DEVELOPMENT DETERMINATION PANEL MEETING

WEDNESDAY 27 NOVEMBER 2024

ITEM 3.1	DA2024/1165 - 31 ALEXANDRA CRESCENT BAYVIEW - CONSTRUCTION OF A DWELLING HOUSE INCLUDING SWIMMING POOL
----------	---

DEVELOPMENT APPLICATION ASSESSMENT REPORT

Figure 1. Proposed Cut & Fill Section (Drawing No.DA 308, Revision A dated 11 October 2024 prepared by Endrim)

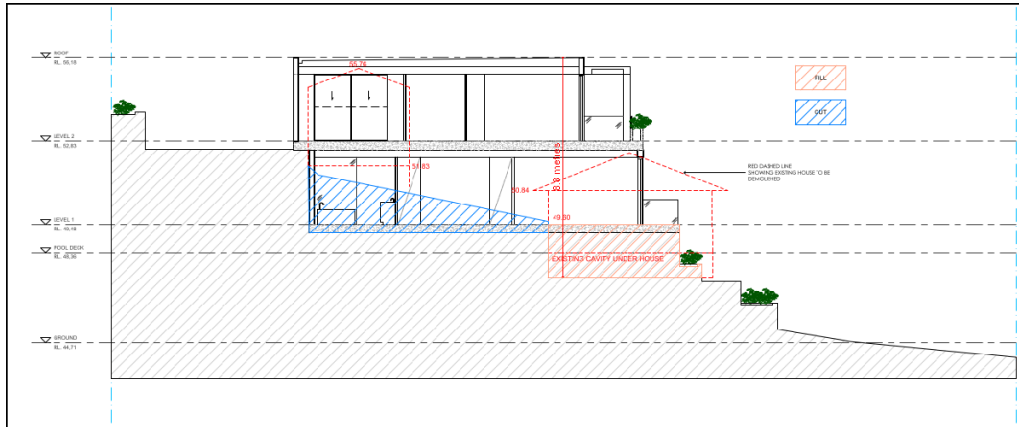
The applicant submitted Proposed Cut & Fill Sections (Drawing No.DA 307-DA 308, Revision A dated 11 October 2024 prepared by Endrim). Whilst the Section Plans do not include a 8.5m building height plane, the plans indicate a proposed height of 8.8m as a result of the existing ground level of the cavity under the existing dwelling house (see Figure 1).

As such, the proposal is non-compliant with Clause 4.3 Height of buildings and is not accompanied by a written Clause 4.6 variation request. Therefore, as a written Clause 4.6 variation request was not submitted with the development application, and the building height exceeds the maximum prescribed by the LEP, Council cannot be satisfied that compliance with the development standard is unreasonable or unnecessary in the circumstances, and that there are sufficient environmental planning grounds to justify the contravention of the development standard.

Figure 7. North Elevation (red highlighting building envelope variation)

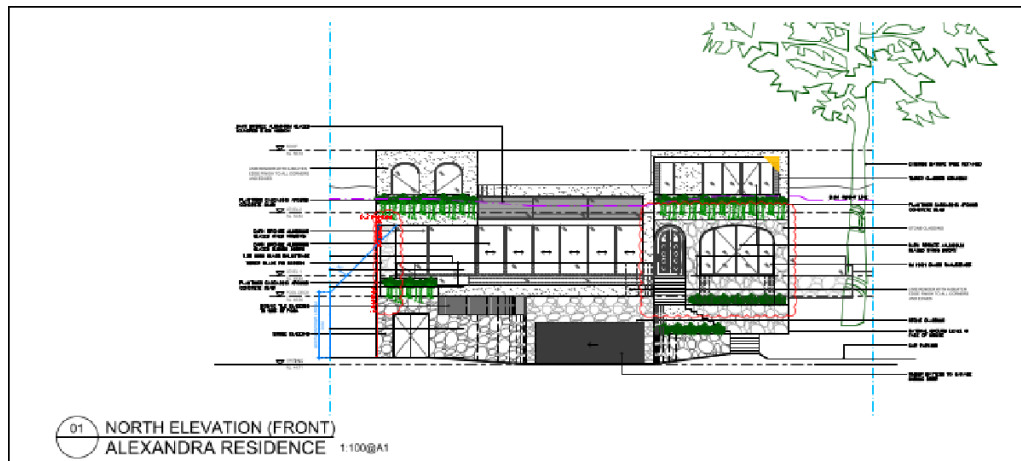
The proposed dwelling house encroaches outside of the building envelope on the north elevation by an approximate maximum height of 1.0 metres for a horizontal length of 0.2 metres, resulting in a maximum variation of 16.67% as outlined in Figure 7.

Figure 8. East Elevation (red highlighting building envelope variation)

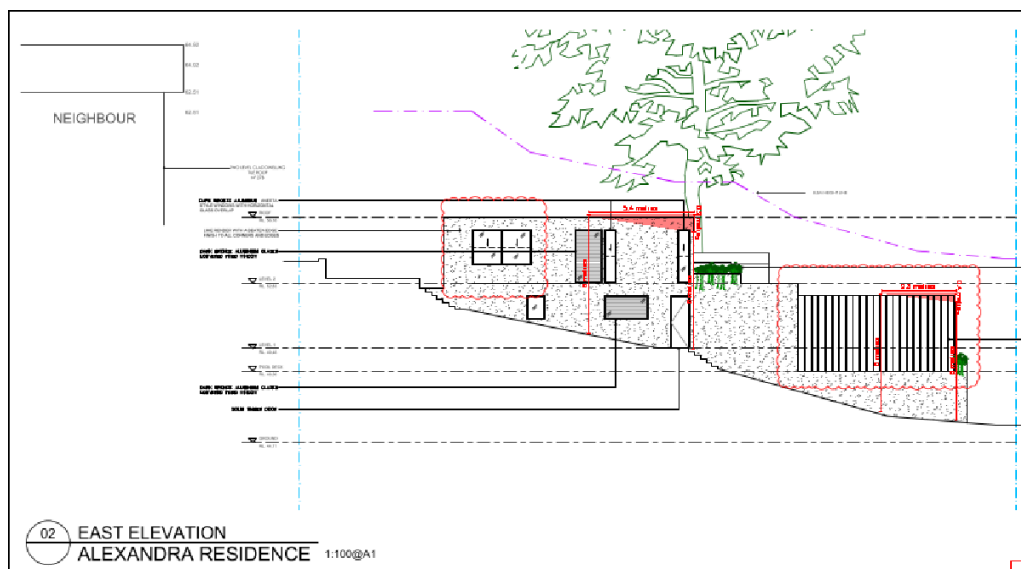
The proposed dwelling house encroaches outside of the building envelope on the east elevation by an approximate maximum height of 0.9 metres for a horizontal length of 5.4 metres, resulting in a maximum variation of 15.0% as outlined in Figure 8.

Figure 9. West Elevation (red highlighting building envelope variation)

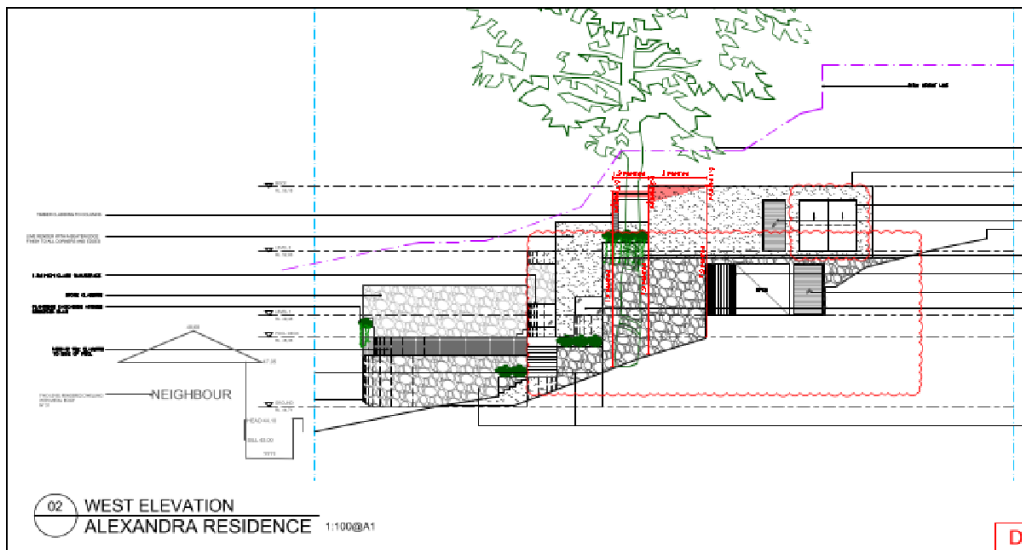
The proposed dwelling house encroaches outside of the building envelope on the west elevation by an approximate maximum height of 0.9 metres for a horizontal length of 3.0 metres, resulting in a maximum variation of 11.39% as outlined in Figure 9.

It is important to note the non-compliance with the building envelope control was raised with the applicant, however no changes were made to the architectural plans.

Figure 1: Section plan - Height of building variation in pink.

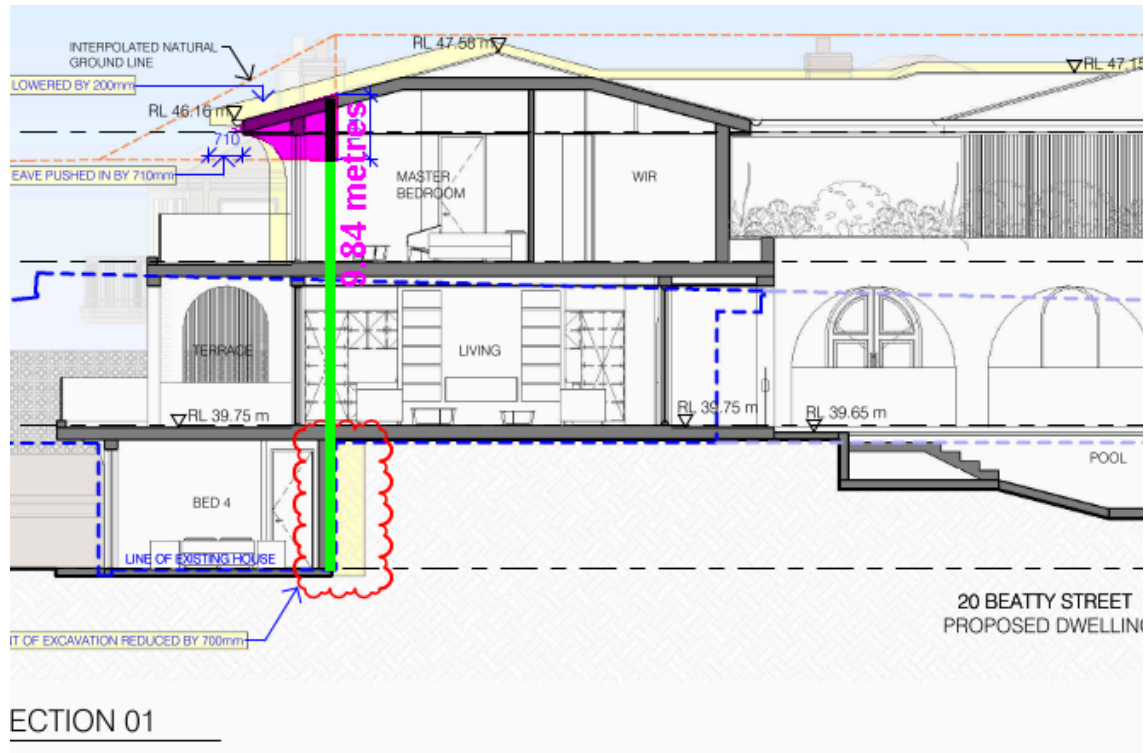
Proposed: 9.841m

Percentage of variation: 15.77%

Figure 1: Proposed overshadowing of no. 84 Cutler Road shown in orange

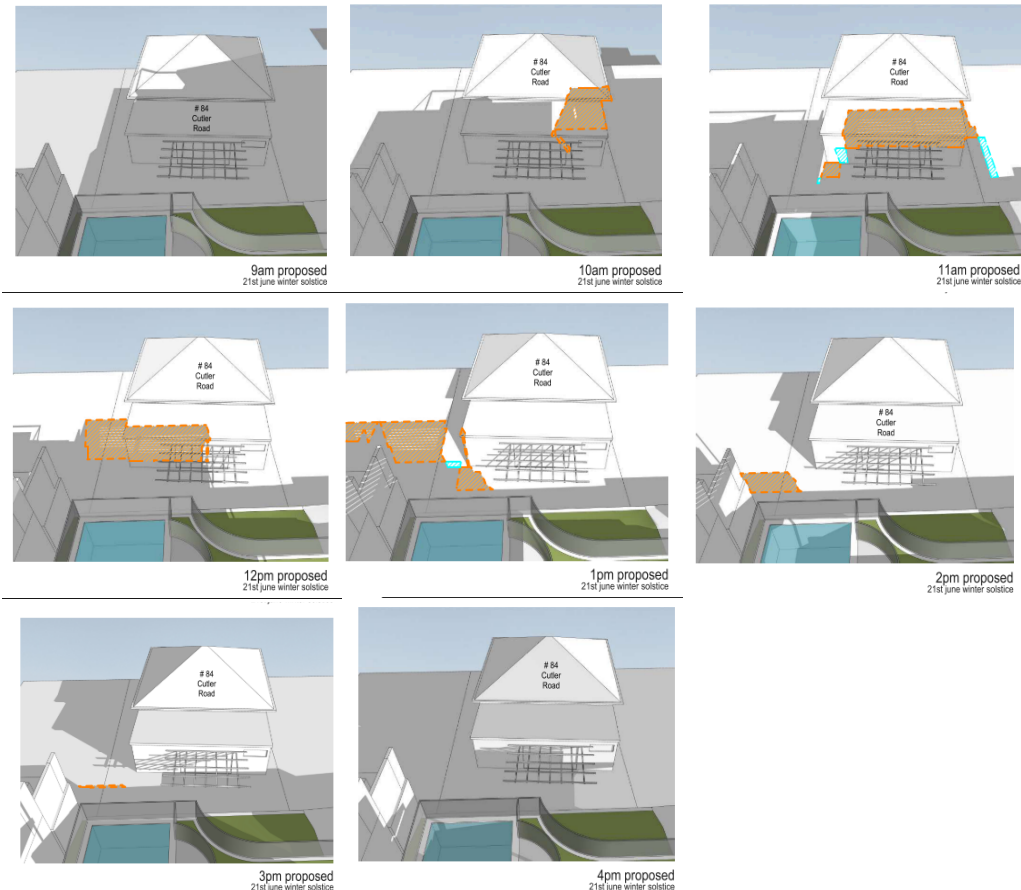
Shadow diagrams for the Winter Solstice have been provided with this application, which indicates overshadowing to no. 84 Cutler Road (the property to the south) at 9am, 12noon and 3pm on the winter solstice. Due to the orientation of the allotments and the slope of the land (no. 84 Cutler Road sits approximately 6.5m below the exiting rear ground level of the site), properties sited to the south of an adjacent building are more vulnerable to overshadowing.

The shadow diagrams submitted with this application indicates that the glazed door on the northern elevation of no. 84 Cutler Road does not receive 4 hours of sunlight on the winter solstice. The proposed development will result in a reduction of the sunlight receive to the dining room glazed door between 11am and 1pm on the winter solstice, which does not comply with the requirement of the control.

Figure 2: Section showing the height difference between the subject site and the rear courtyard of no. 84 Cutler Road

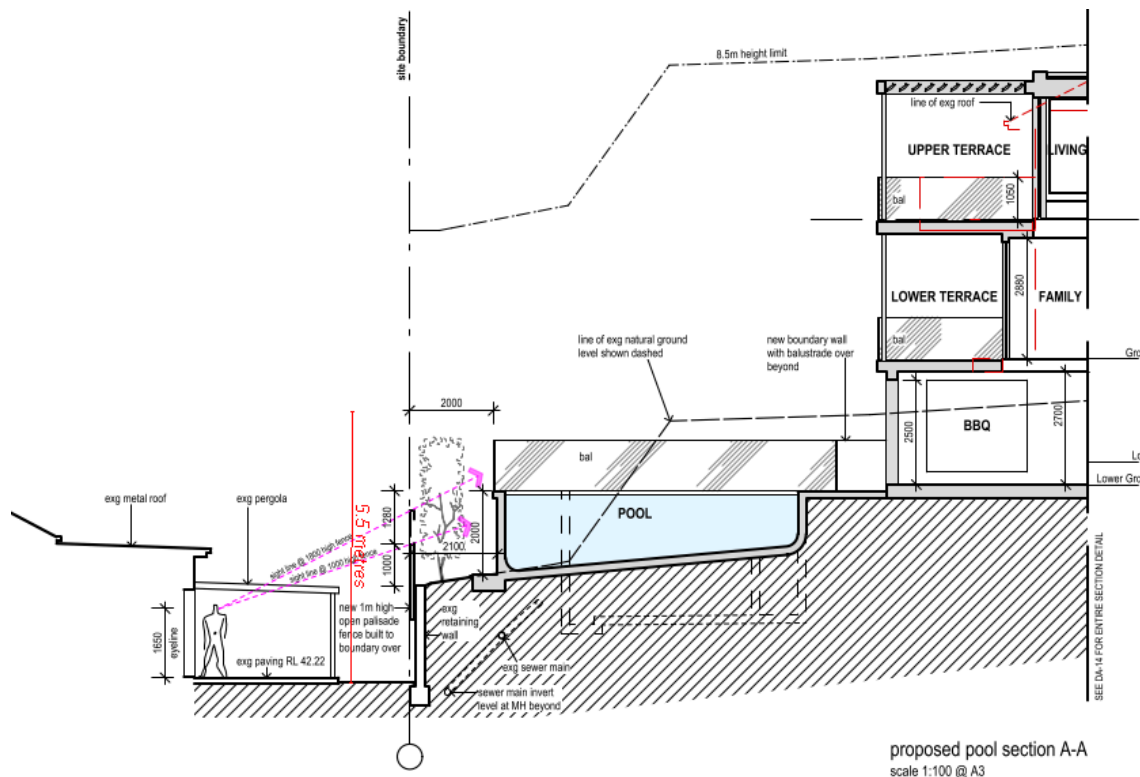
No. 84 Cutler Road is highly susceptible to overshadowing as it is a north-south orientated site and located on the downward slope from the proposal. The rear courtyard/private open space of no. 84 Cutler Road has been excavated below natural ground level and is 6.5m lower than the existing rear yard of the subject site. Furthermore, the northern elevation of the dwelling (where the glazed door is located) at no. 84 Cutler Road has a reduced rear setback of 4.6 - 5.1m from the rear boundary.

Whilst there are minor numeric variations to this control, it is considered that the level of solar access maintain to adjacent properties is equitable. As mentioned above, the southern adjacent site is particularly vulnerable to shadowing due to the topography of the sites and site orientation.

Figure 6: East elevation with wall height non-compliance shaded in red.

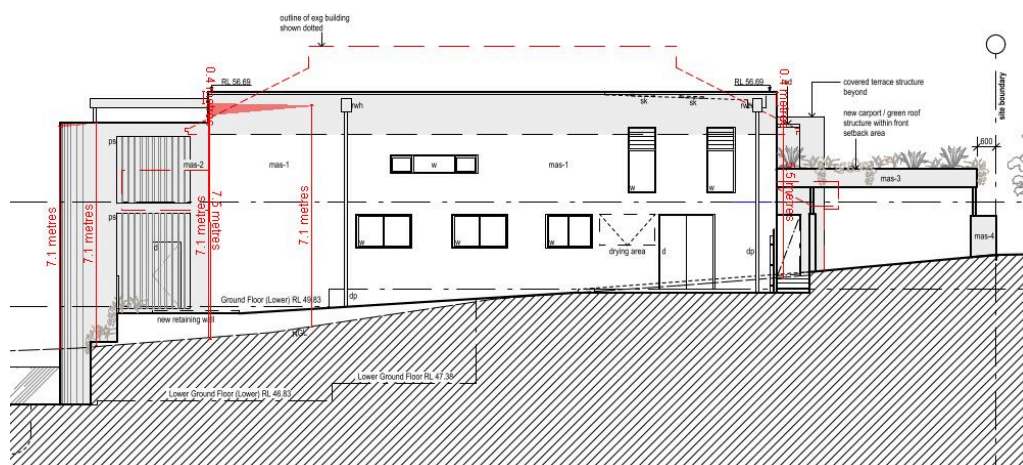
The proposed first floor extension results in non-compliant wall heights on the eastern and western elevations, with respective external wall heights with a maximum height of of 7.5m and 7.7m. As a consequence, the proposed development fails to comply with the requirements of the control.

Figure 6: proposed cut and fill plan.

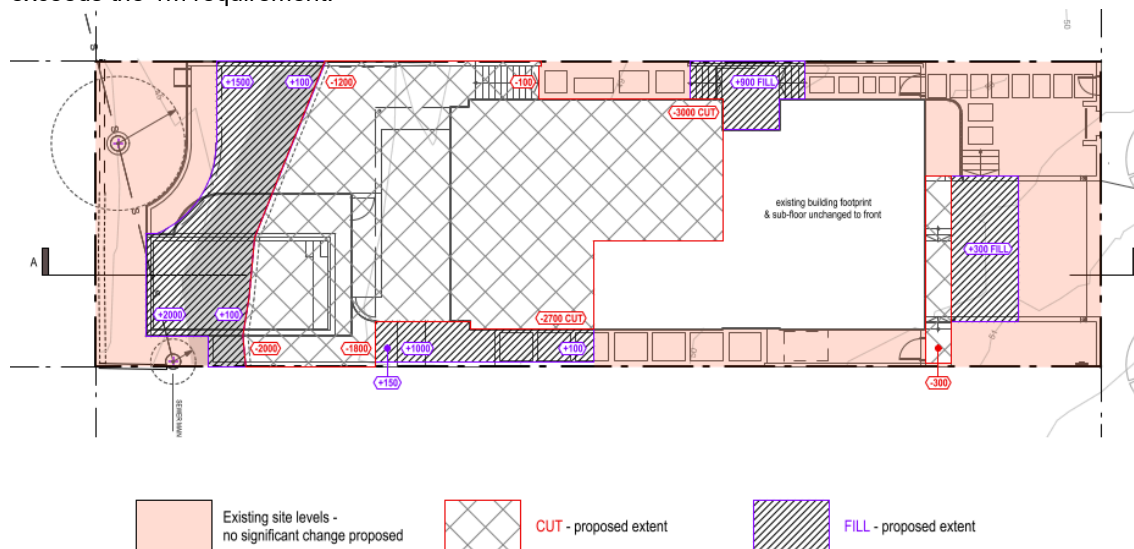
The proposal involves excavation and fill within the rear yard. The excavation ranges from 3 -2.7m under the existing dwelling to 1 - 2m within the rear yard. The fill ranges from 0.3 - 2m in height, which exceeds the 1m requirement.

Figure 1. Section S-01 (red shaded area highlighting extent of variation)

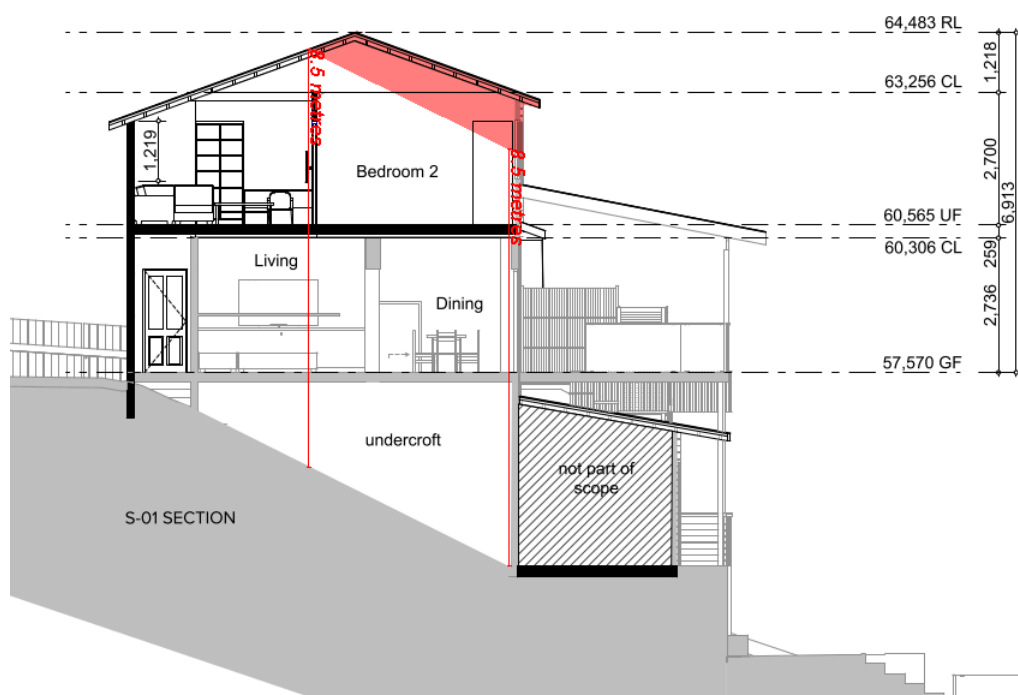
Percentage of Variation: 15%

Figure 2. South Eastern boundary envelope encroachment.

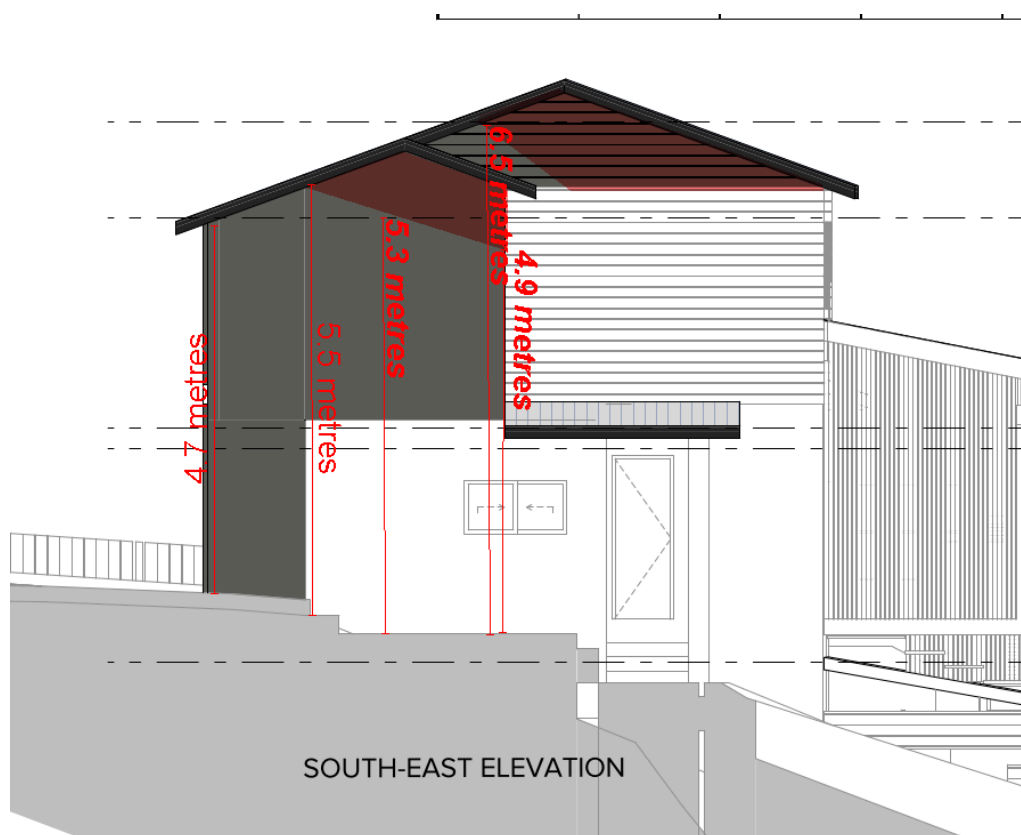
The proposed first floor extension encroaches into the building envelope along part of the south eastern elevation to a height of 1.3 metres over a length of 6.6 metres:
